RS-06-109

Braidwood Station, Units 1 and 2
Facility Operating License Nos. NPF-72 and NPF-77
NRC Docket Nos. 50-456 and 50-457

Byron Station, Units 1 and 2
Facility Operating License Nos. NPF-37 and NPF-66
NRC Docket Nos. 50-454 and 50-455

Subject: Response to Request for Additional Information Regarding Application for
Steam Generator Tube Integrity Technical Specification

Figure 4: Sketch of Cracked Tube in Tubesheet leading to Leakage Flow-rate, Q_{OUT} .
(Note that the gap shown between the tube and the tubesheet is for illustration purposes only.)

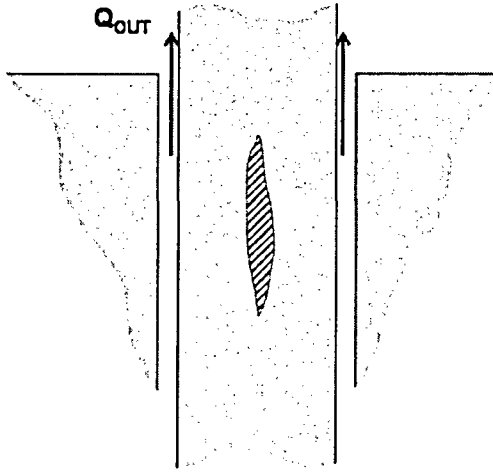
Under the proposed 17-inch tubesheet inspection zone, it is the Exelon's contention that the accident leakage integrity of the tubing below the 17-inch inspection zone is ensured by the bell-weather principle. The NRC staff requests that Exelon submit a leakage sensitivity study to support the conservatism of the bellwether approach. That is, leakage during accidents will not exceed two times that observed during normal operating conditions. The NRC staff requests that this study consider axial and circumferential flaws located at the bottom of the tubesheet at three tubesheet radial locations; i.e., at the zero radius, mid-radius, and peripheral locations. For each type of crack at each location, leakage under normal operating and accident conditions should be evaluated considering only the crack leakage resistance, considering only the tube to tubesheet annulus resistance and, lastly, considering the total resistance of the crack and annulus to leakage.

The complete response to this question is provided on pages 8 through 16 of the proprietary version of SG-SGDA-06-20-P-Attachment, Revision 1 (i.e., Attachment 6 of this submittal) and is identified as "Response 5." Because the response to this question contains information proprietary to Westinghouse, only partial information is provided on pages 8 through 16 of the non-proprietary version (i.e., Attachment 7).

The new model for the axial crack opening that takes into account the guidance and constraint provided by the surrounding tubesheet is described in what follows. See Figure 1, below, for a sketch of the model configuration.

Figure 5: Axial Crack Opening Area as a Function of Crack Length for varying tube diameters at SLB.

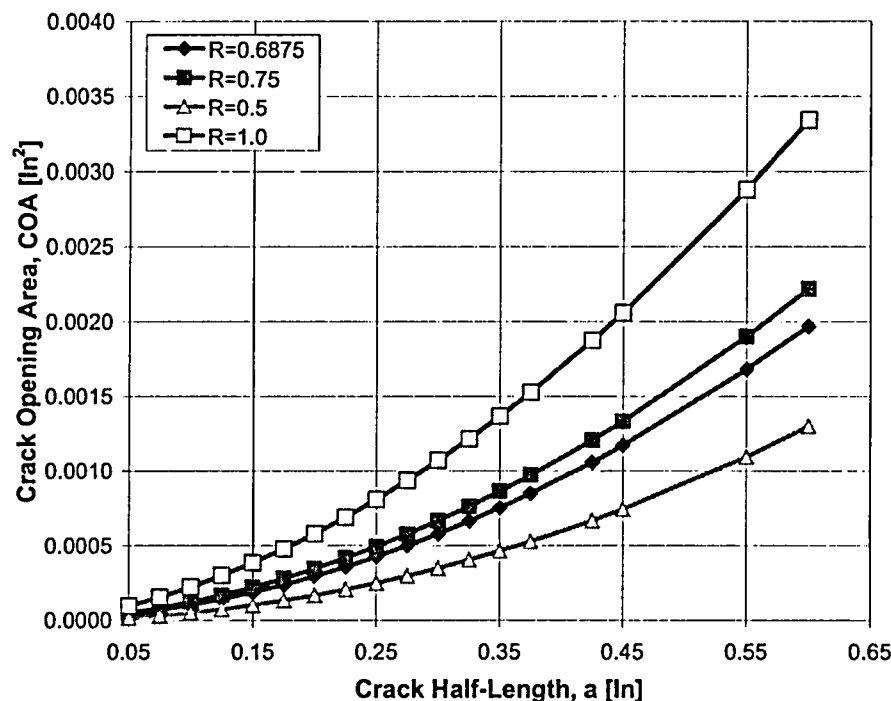
Section 8.2 of Attachment 7 provides a justification for why ligament tearing of circumferential cracks is not a significant concern. Provide a justification for why ligament tearing of axial cracks at the bottom of the tubesheet at the periphery is similarly not a significant concern.

The calculated axial crack opening area can vary with tube size. An increase in the crack opening area is generally proportional to an increase in tube diameter. Comparing crack sizes below 0.65 inch on tubes with diameters of 0.50 and 1.00 inch, the increase in constrained axial crack opening area is predicted to be more than twice the increase in tube size. See Figure 5 for a plot comparing the constrained axial crack opening area (COA) as a function of crack size and tube radius.

The axial crack opening area results shown in the Figure 5 below are not directly indicative of the leak rate behavior during NOp and SLB conditions. However, the axial crack opening area is indicative of other factors that do regulate the leak rate. For instance, an increase in the crack opening area will decrease the potential leak resistance of the crack at NOp and SLB. However, this decrease in leak rate resistance due to the crack is comparable for both conditions; therefore, the leak rate ratio will remain relatively unchanged. The bellwether principle is still reasonable for various tube diameters with respect to the constrained axial crack opening area and the conclusions stated for the Model F steam generator tube size discussed above can be generically applied.

Figure 1: SLB design pressure change history.

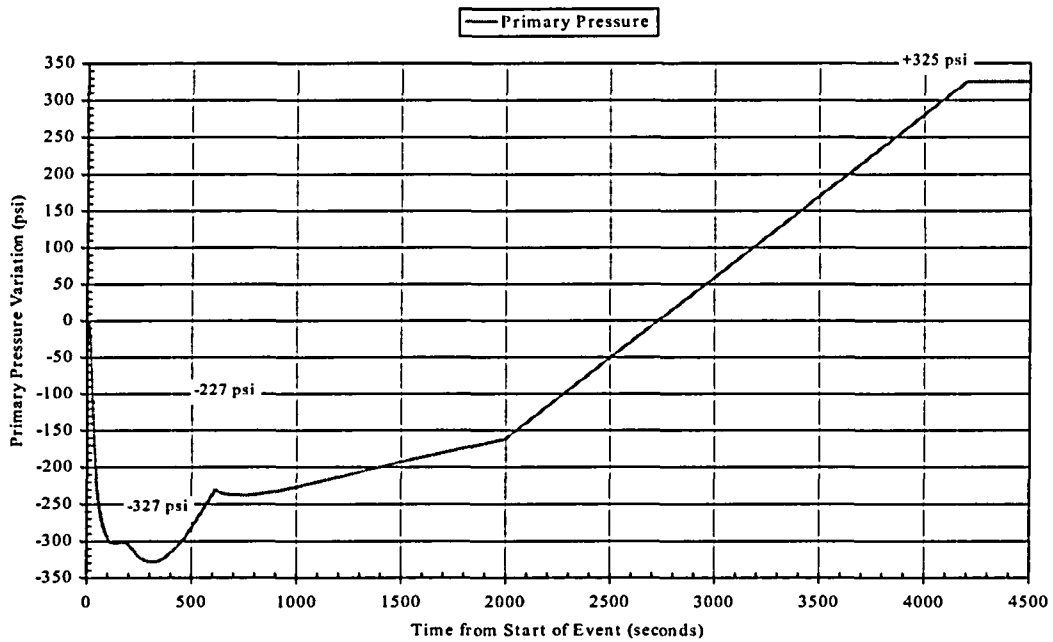
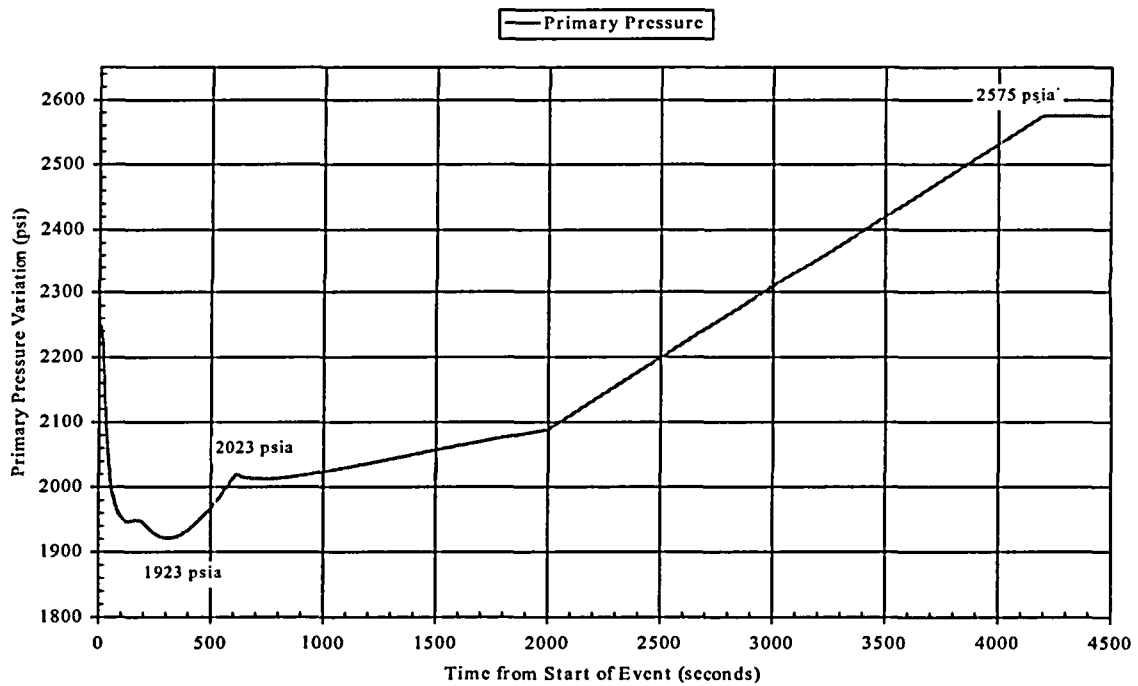
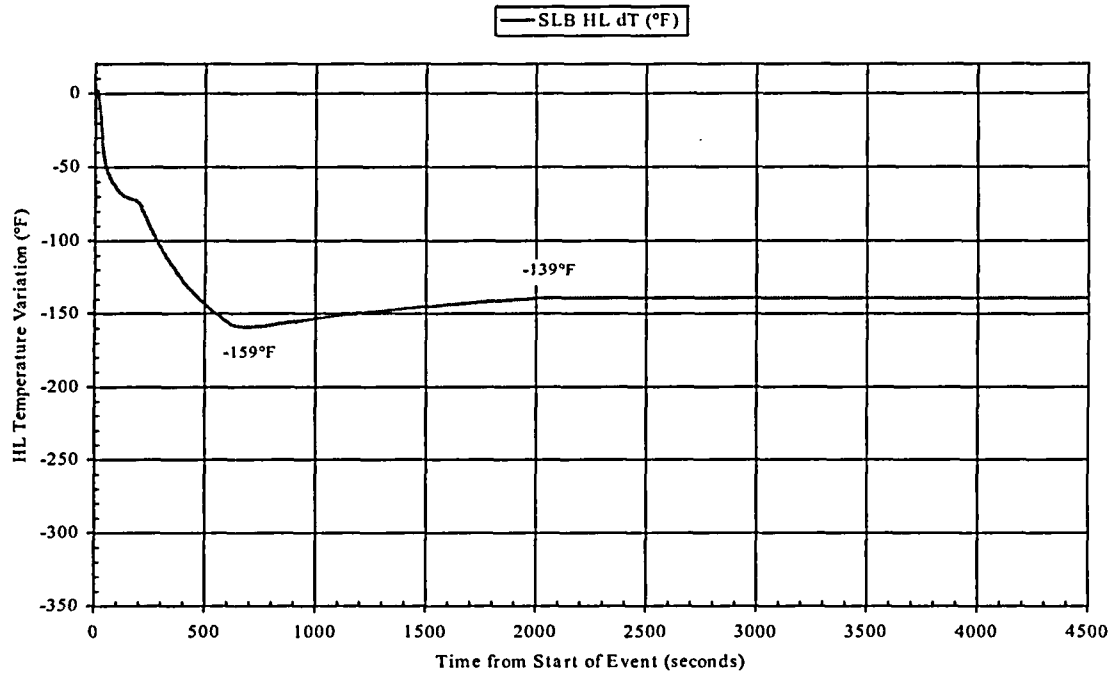
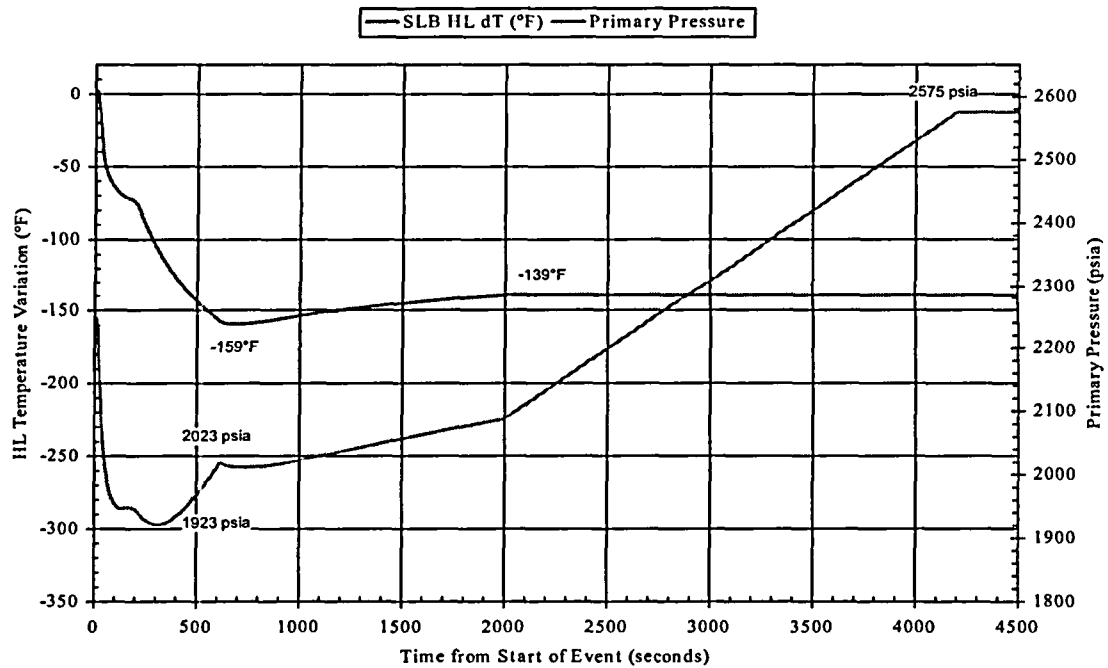
NRC RAI 6: The bellweather principle maintains that the increase in primary to secondary leakage when going from normal operating to accident conditions is bounded by a factor of 2. This is based, in part, on an assumed main steam line break (MSLB) and feed line break (MFLB) pressure differential of 2560 and 2650 psi, respectively, and a temperature of 600 degrees F. Provide the rationale which supports the conservatism of the 600 degree F assumption. This rationale should consider the time history of primary and secondary pressure and temperature during the accident. The staff's purpose in asking this question is ensure the time integrated leak rate is bounded by the bellweather principle factor of 2 increase relative to normal operating leakage. Provide the primary pressure and temperature curves as a function of time for the MSLB and MFLB accidents under consideration. Also, provide the rationale supporting the conservatism of the bellweather principle for a large break loss of coolant accident.

The calculation of the leak rate during a postulated SLB event is not based on a temperature of 600°F, but on the temperature obtained from an examination of the equipment specification curves for the transient. In addition, the calculation of conditions during normal operation is based on a set of umbrella values resulting in considering primary fluid temperatures of 604.3 and 621.4°F for secondary side pressures of 782 and 947 psig respectively. Both conditions are used. The SLB transient is assumed to initiate while the plant is at hot standby conditions, i.e., 557°F. The primary temperature drop is 139°F leading to an analysis temperature of 418°F. The secondary temperature drop is 307°F leading to a shell temperature of 260° for the analysis. The design specification pressure changes are illustrated on Figure 1 and the actual pressures for Seabrook are shown on Figure 2. The design specification temperature history during a postulated SLB event is shown on Figure 3. The superposed curves are shown on Figure 4. It is readily seen that the most limiting differential pressure, 2575 psi, occurs when the temperature is at a relatively steady state for both the hot and cold legs. The analyses were performed for the conditions at about 600 seconds into the transient and found to be less limiting than when the pressure difference is at a maximum. The H* engagement length required to resist the SLB differential pressure with a margin of 1.4 is about 0.15 inch greater for the latter condition. The B* length to restrict the SLB leak rate to a factor of 2 relative to that during NOp, based on the method of calculation, is about 7% longer for the conditions at 4200 seconds relative to those at 600 seconds. Examination of Figure 4 leads to the conclusion that the differential pressure is the controlling factor and the value at 4200 seconds will bound any value in between the two.
